**HISTORIC LANDMARK COMMISSION**  
**AUGUST 22, 2011**  
**CERTIFICATE OF APPROPRIATENESS**  
**LHD-2011-0013**  
**705 Baylor**  
**Castle Hill Local Historic District**

Request a Certificate of Appropriateness to add a ½ story cross gable addition to a 1 1/2-story single family home.

PLANS

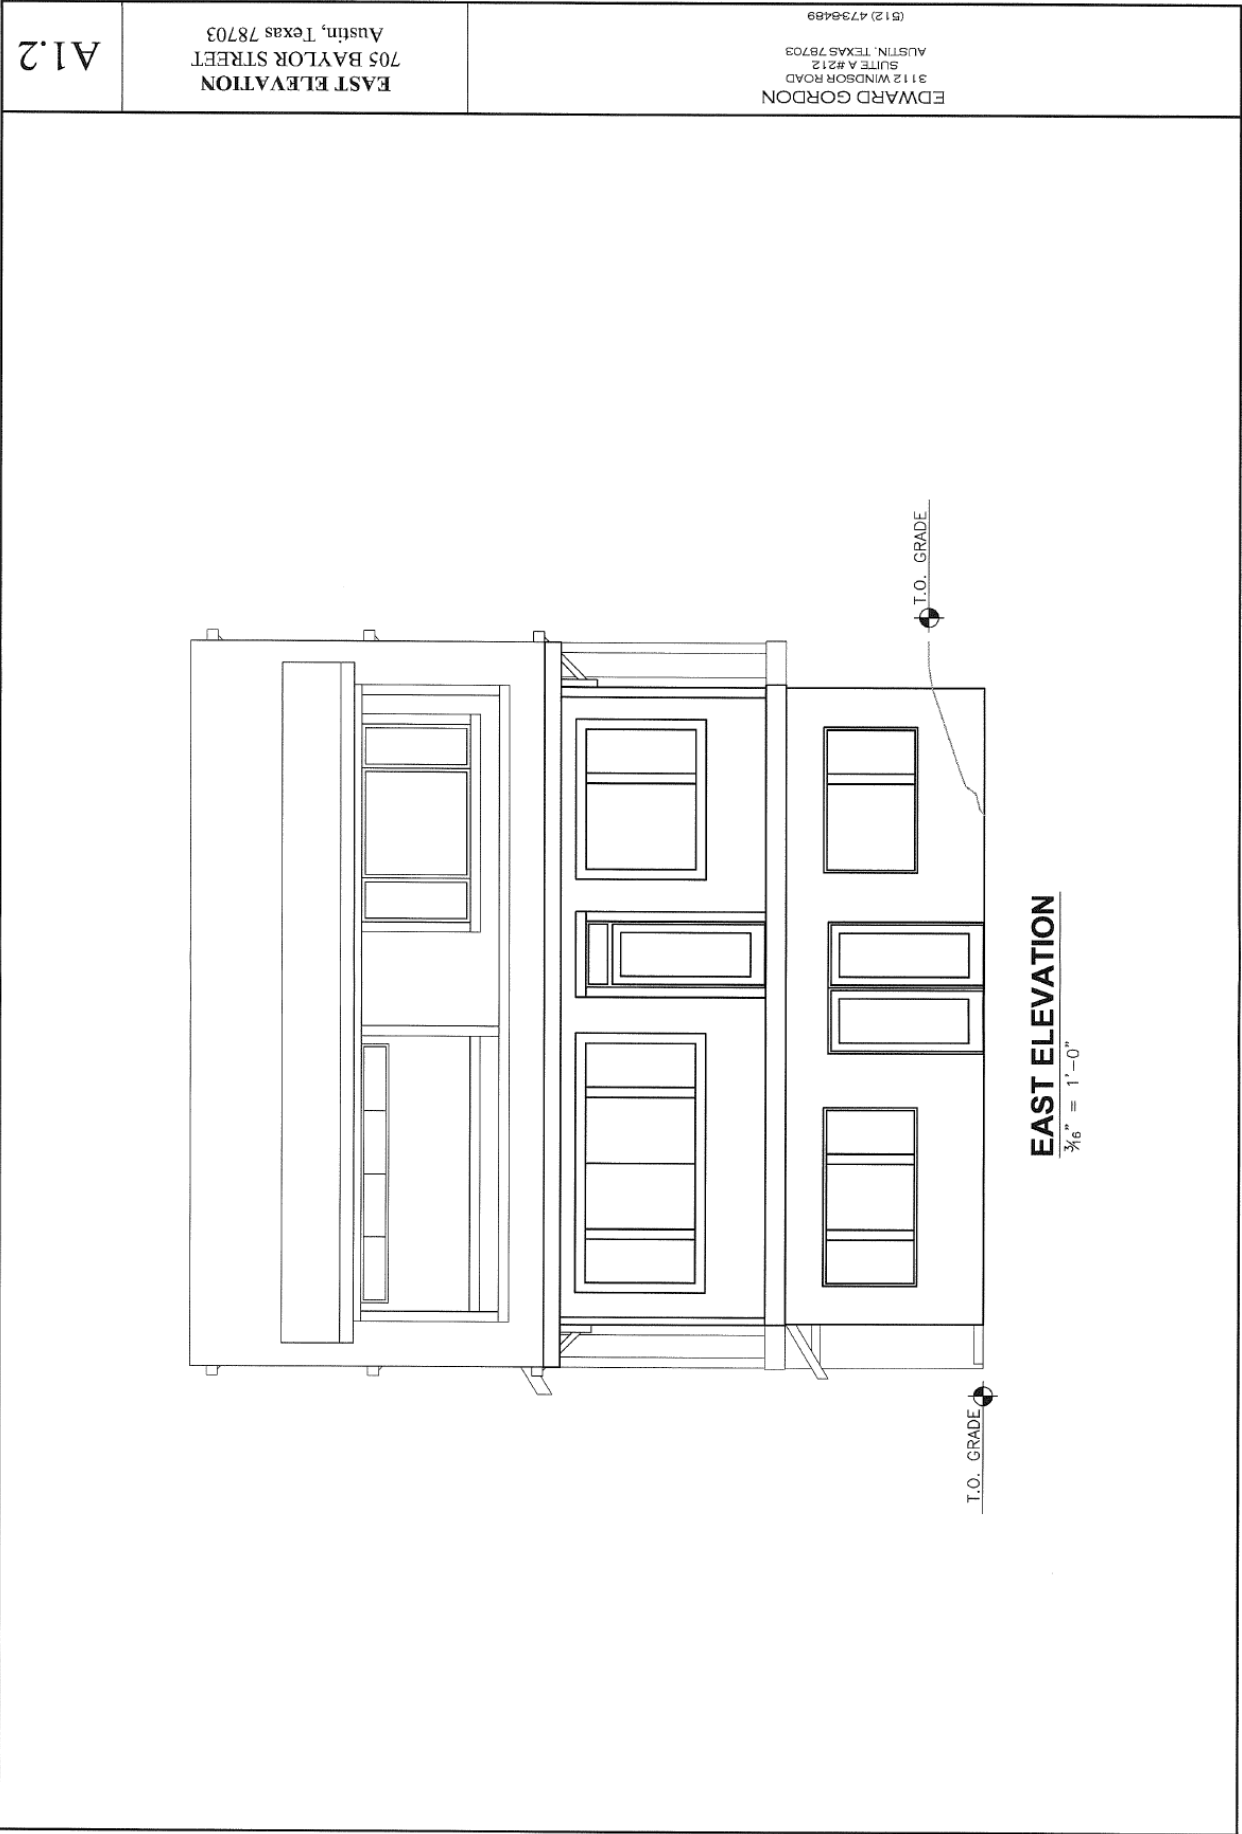
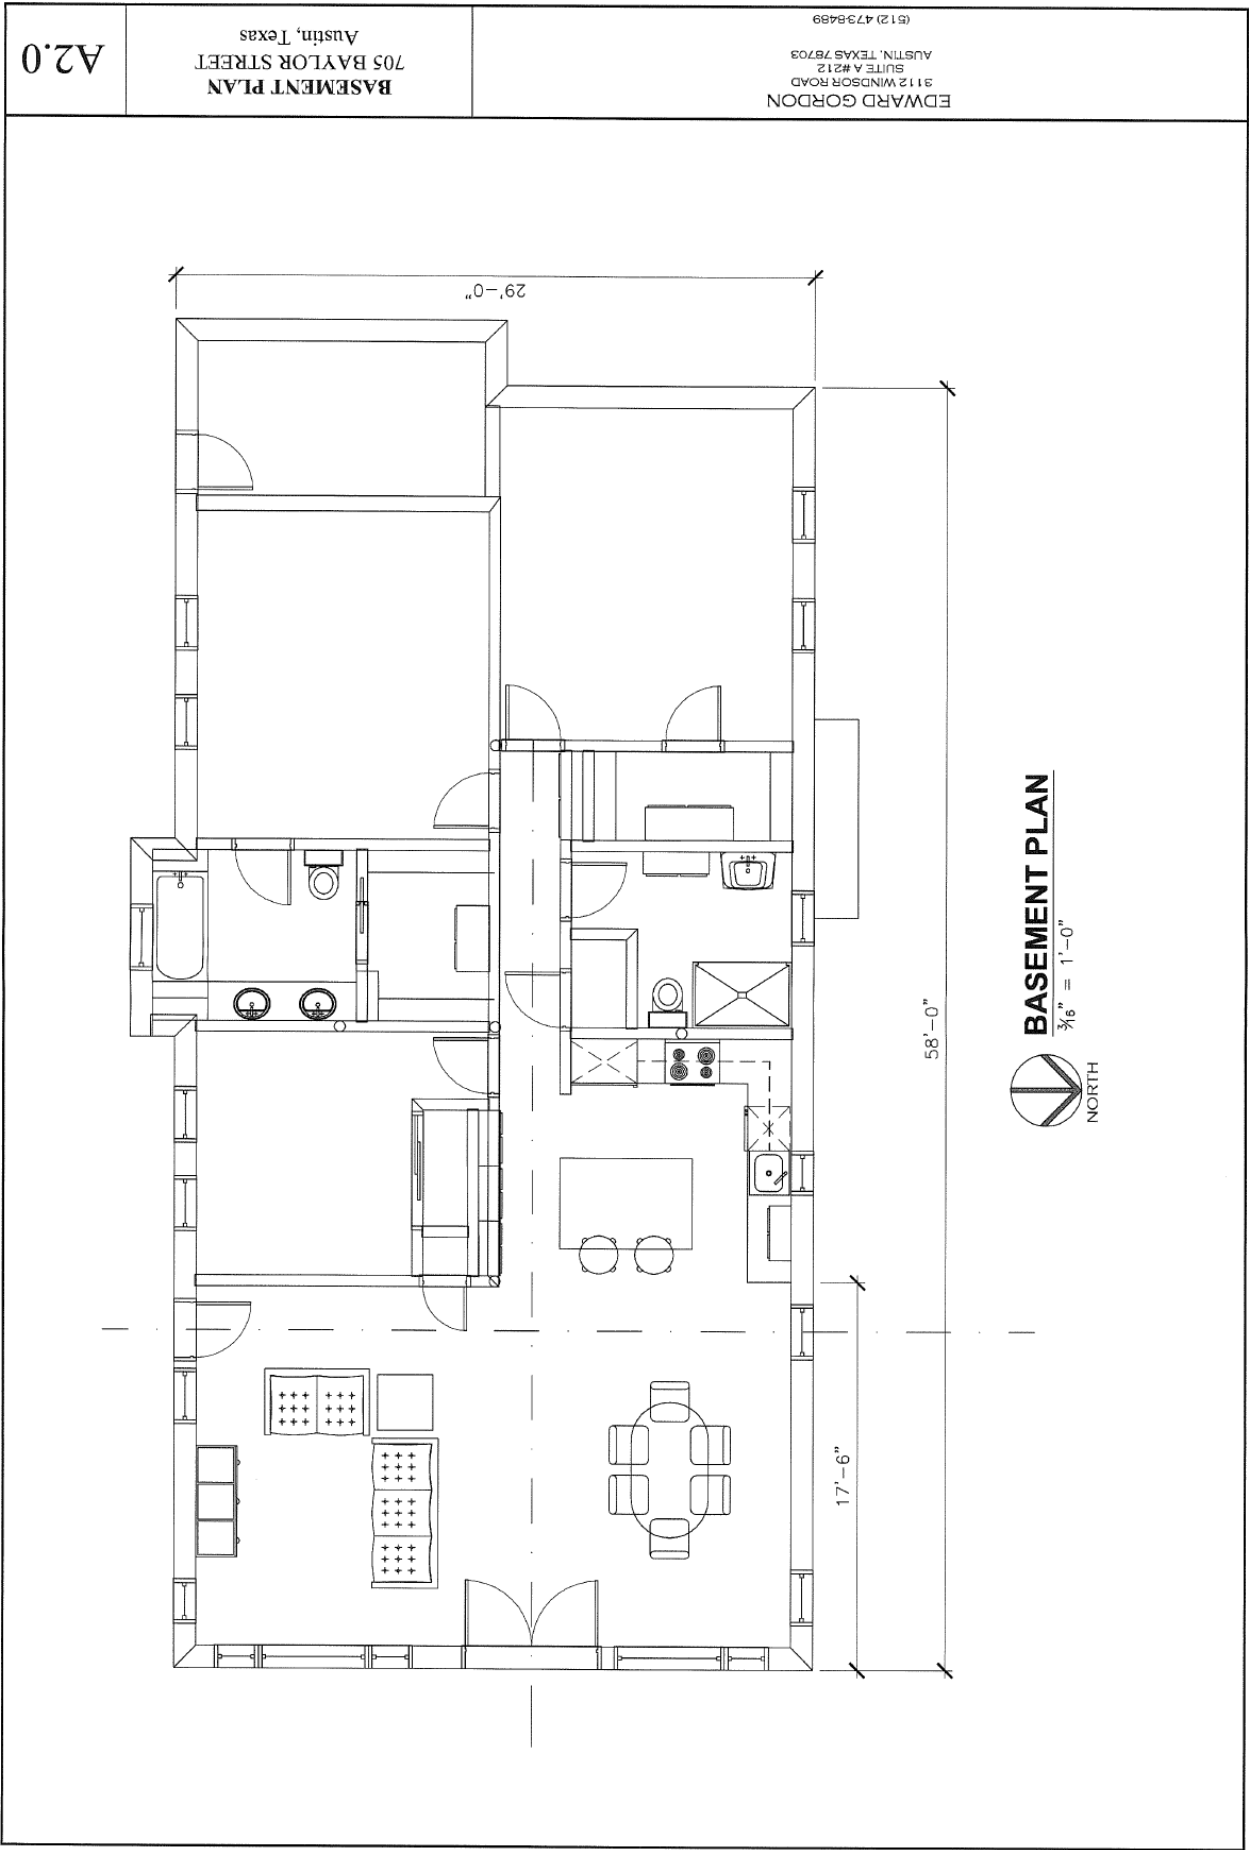
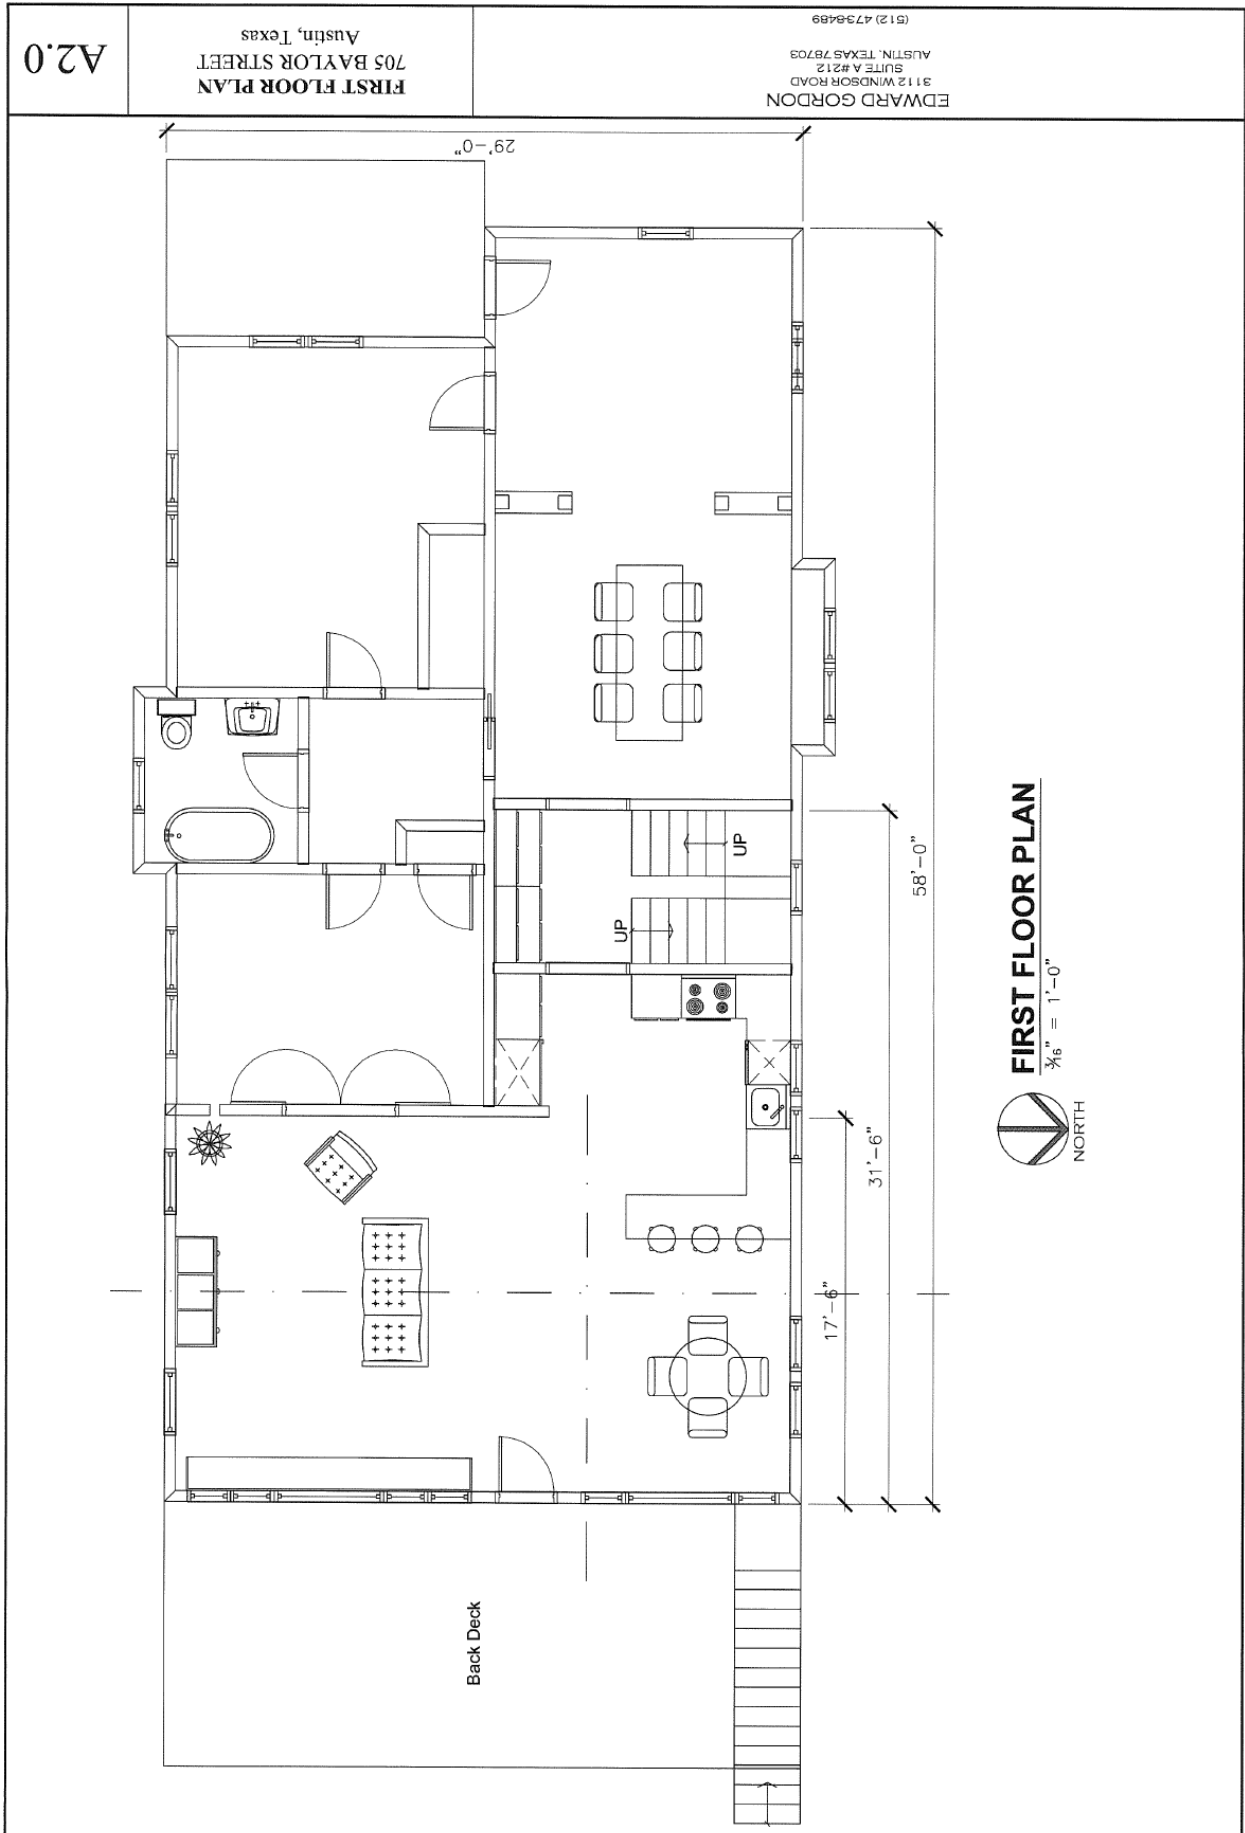
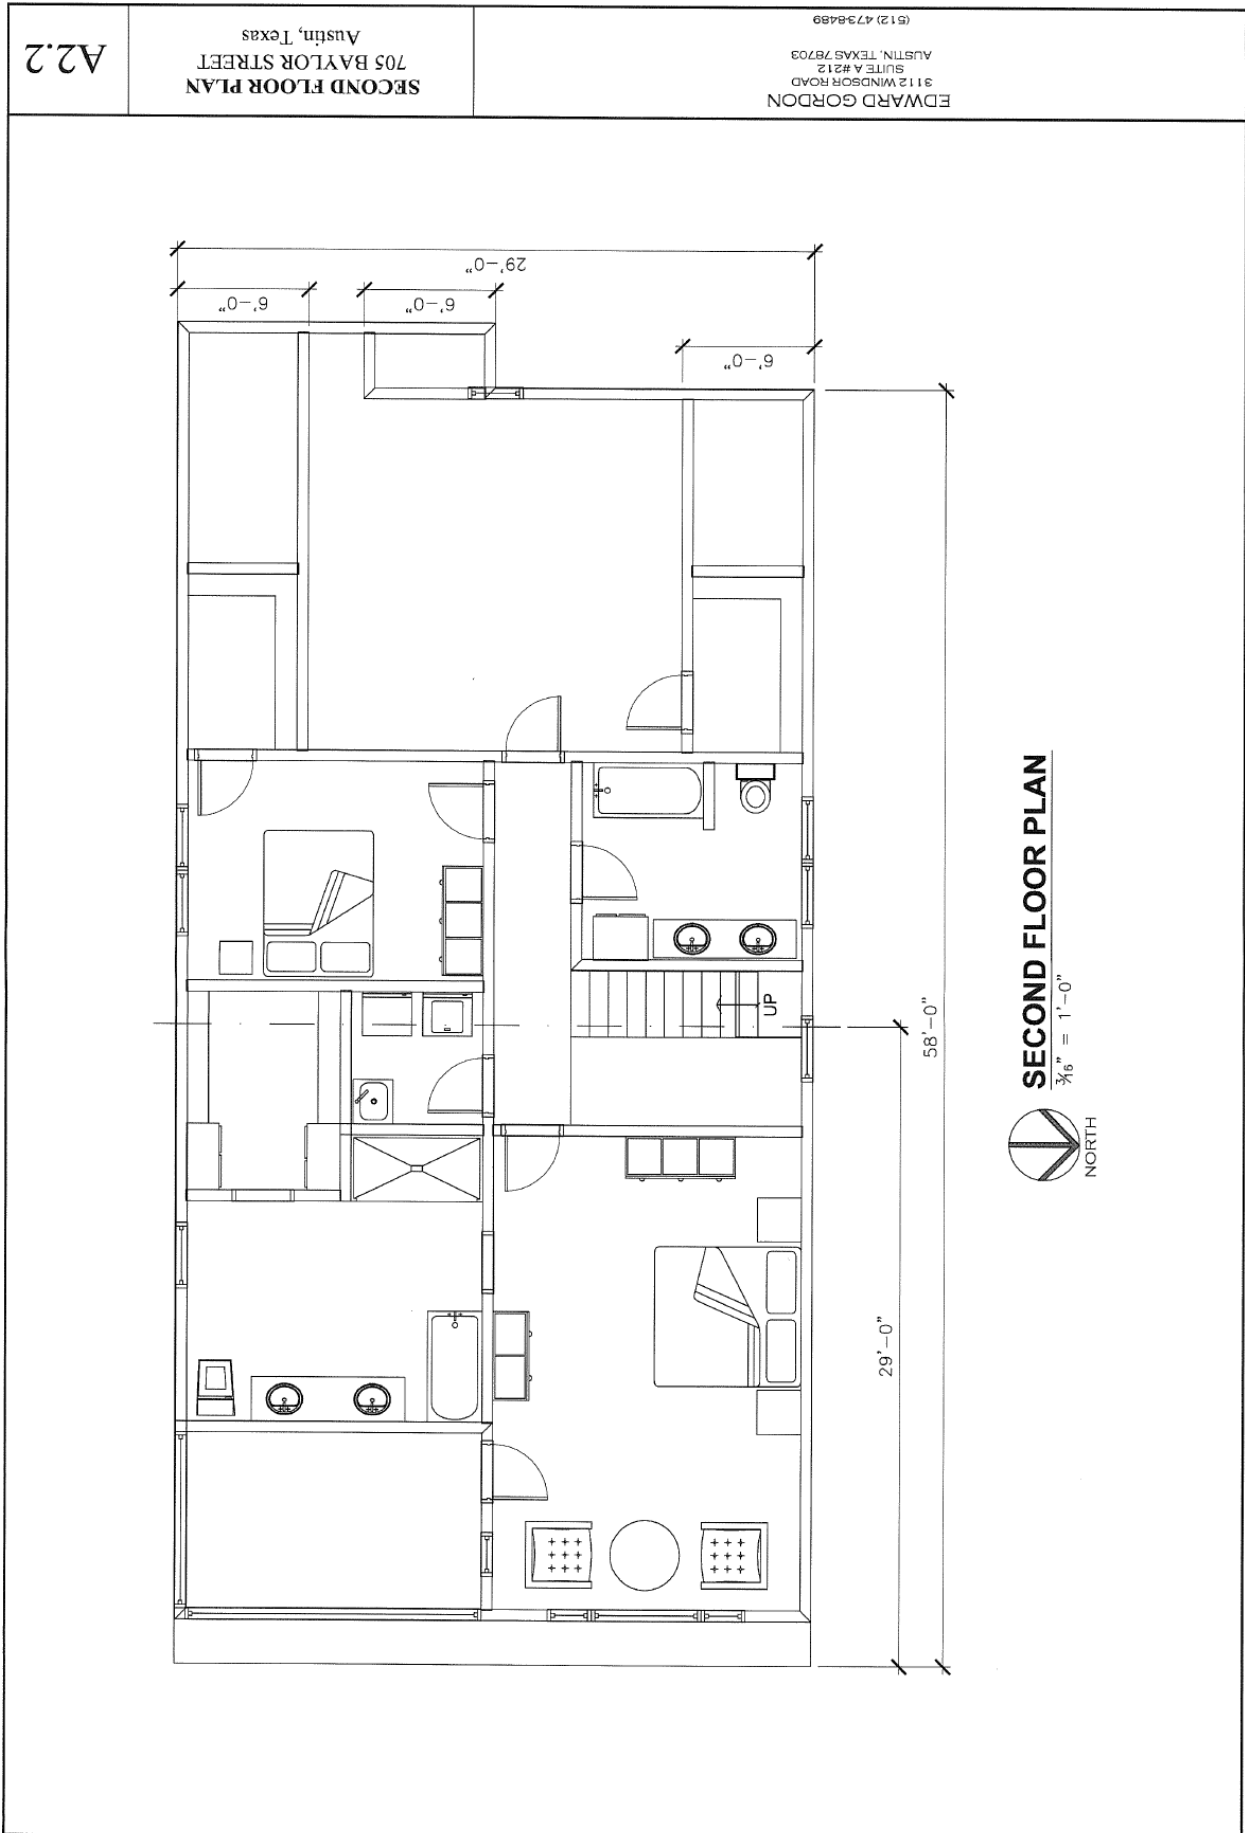
The Committee reviewed the project on August 8, 2011 and recommended approving the project with suggested changes to the windows for the tympanum of the front gable and brick instead of limestone skirting for the foundation.

Staff recommends approving the project as proposed, with the exception that the brackets on the new gable ends be eliminated to differentiate the new roof from the historic roof.
